COMMENT #3: PARK PLANNING AGREEMENTS

COMMENT #11: DESIGN ELEMENTS AND LANDSCAPING

Exhibit 6. Landscape Treatment Comparison

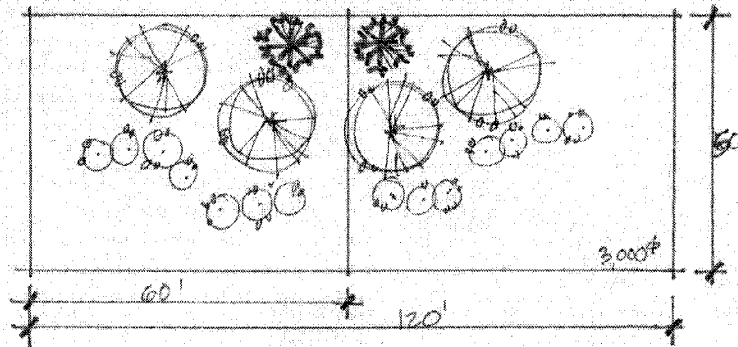
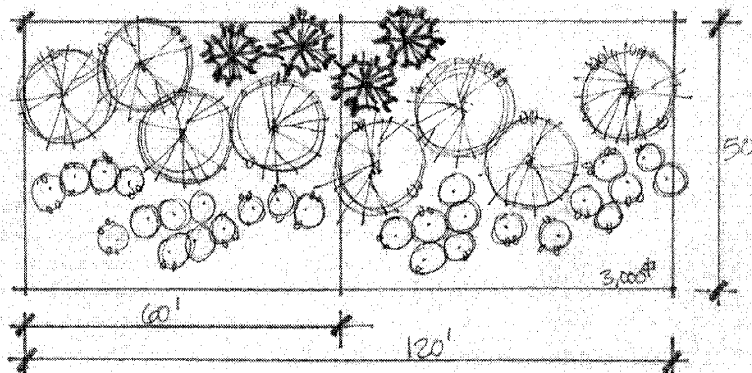
- Substantially increase the amount of plant material in order to adequately achieve a parkway character within a shorter time frame than the 15 to 20 years that would be required given the level proposed in the draft performance specifications. Exhibit 6 provides a comparison of the effect of the staff recommendations

Provide: 1 evergreen tree, 2 shade trees and 7 shrubs for every 3,000 sq ft. of landscape planting zone area.

Provide: 2 evergreen trees, 4 shade trees and 14 shrubs for every 3,000 sq ft. of landscape planting zone area.

Exhibit 8

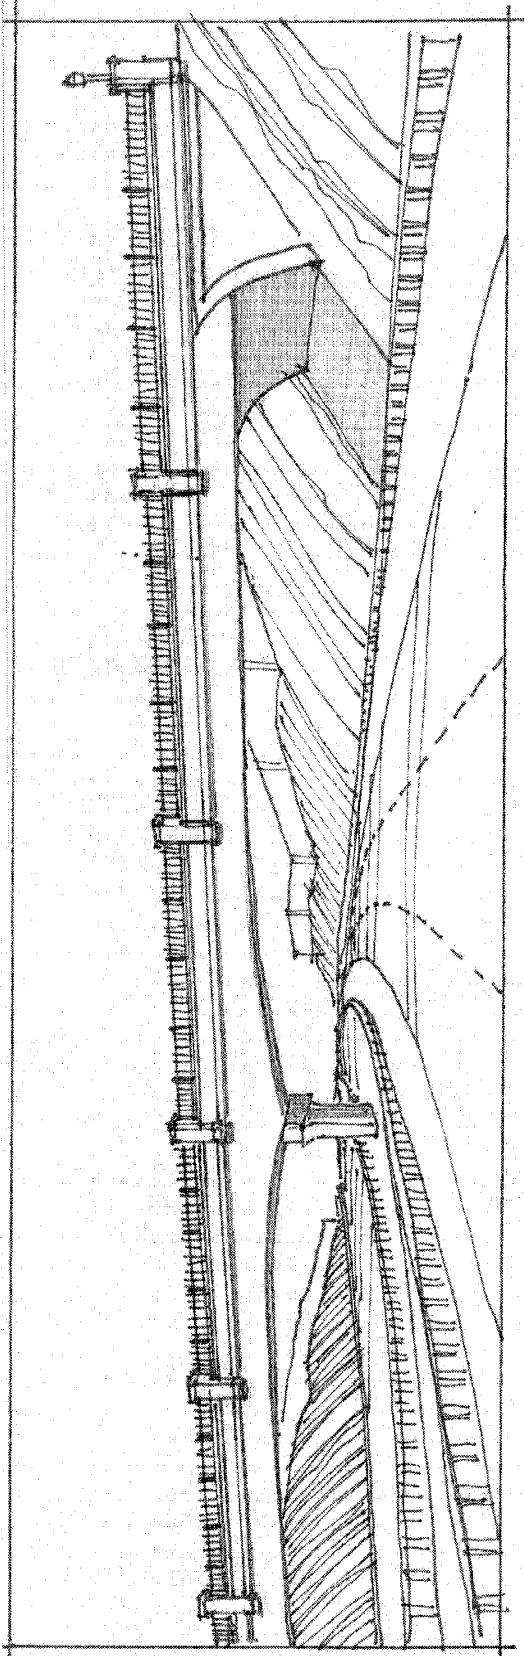
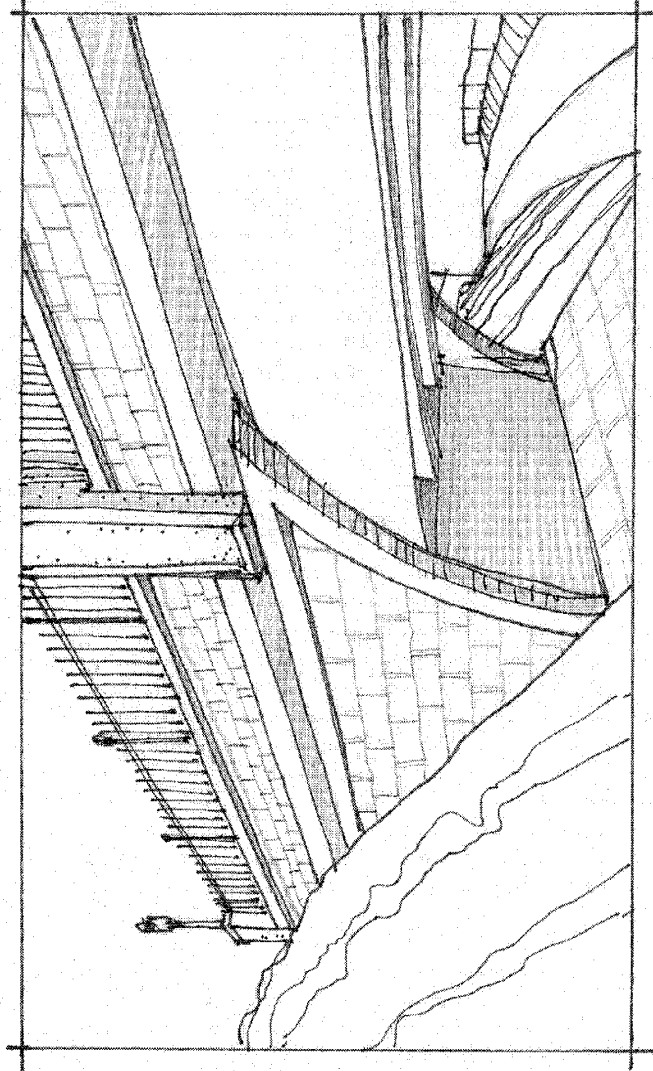
Staff recommends a cross-road classification scheme for bridge treatments described in Attachment B, comment PS 301-7. Three types of bridges; A, B, and C; should be used for community roadways depending upon the location and type of each road. The proposed staff design concepts for these types of bridges are shown in Exhibits 8 and 9

Type A: Bridges with low railing

Type B: Bridges with high railing

- Use ashlar stone pattern on precast parapet wall with variation in size and color of stones.
- Use low ornamental railing with balusters to reduce visual horizontal span of the bridge and add visual interest.
- Add light poles to end posts to add visual interest and highlight bridge.

- Use same design as Type A and increase height of railing and balusters for pedestrian safety.

Exhibit 9

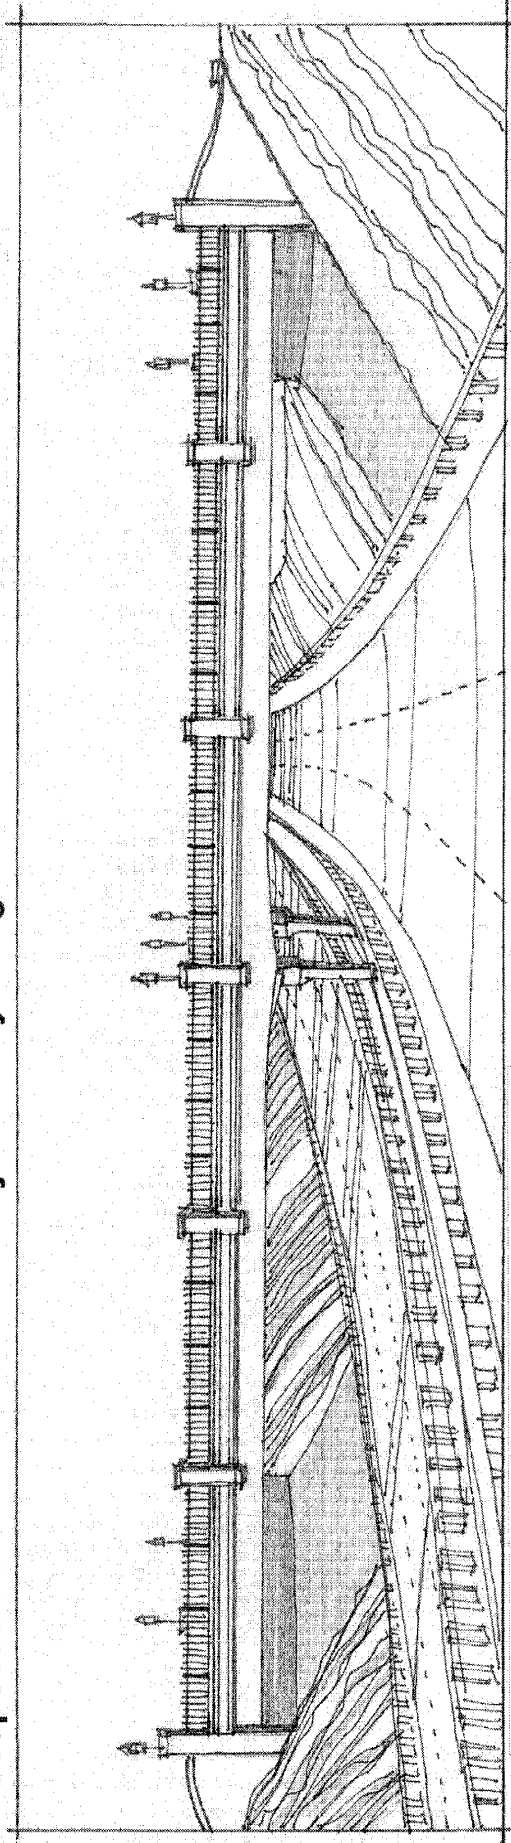
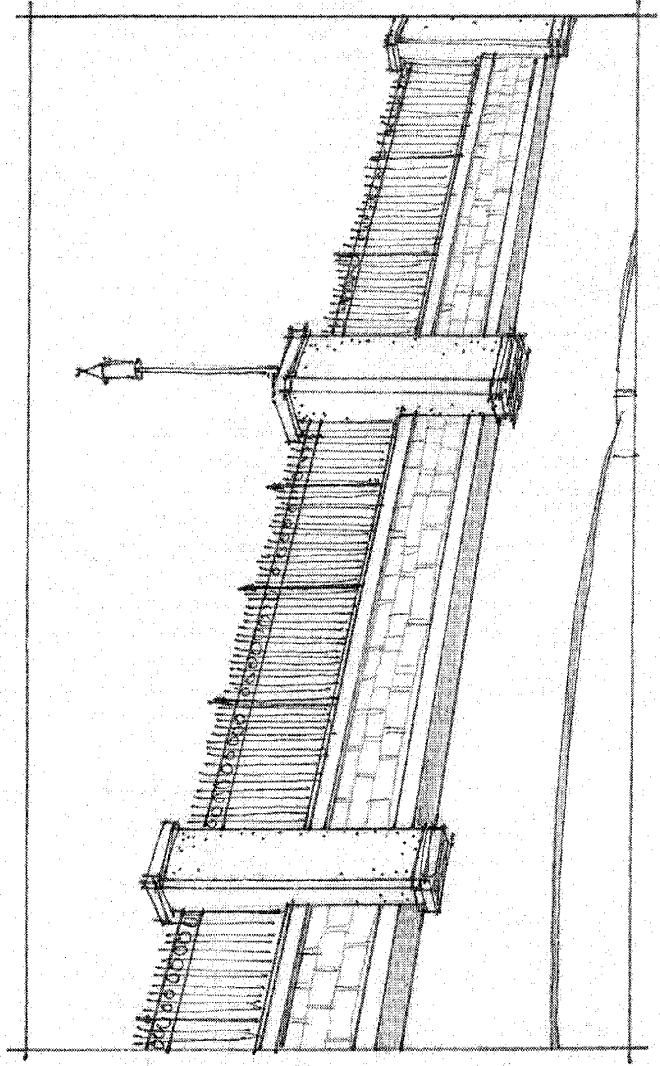
The May 2006 Aesthetic Elements document included in the mandatory referral submission proposes four types of bridge designs, two for roadways and two for park bridges. The design changes recommended by staff are intended to reduce the visual horizontal span of the bridges by introducing vertical elements such as intermittent balusters along the parapet wall and on Community Gateway bridges with bumped out balusters to receive the light poles. The MD 22 bridge over I-95 in Aberdeen, shown in Exhibit 7, is a good example of such treatment. These proposed design revisions add more ornamental railing and decorative lighting to ICC bridges that are viewed by the community.

Type C: Bridges with lighting

- Use ashlar stone pattern on precast parapet wall with variation in size and color of stones.
- Use high ornamental railing with balusters to reduce visual horizontal span of the bridge and add visual interest.
- Reduce number of light poles while still achieving adequate light levels.
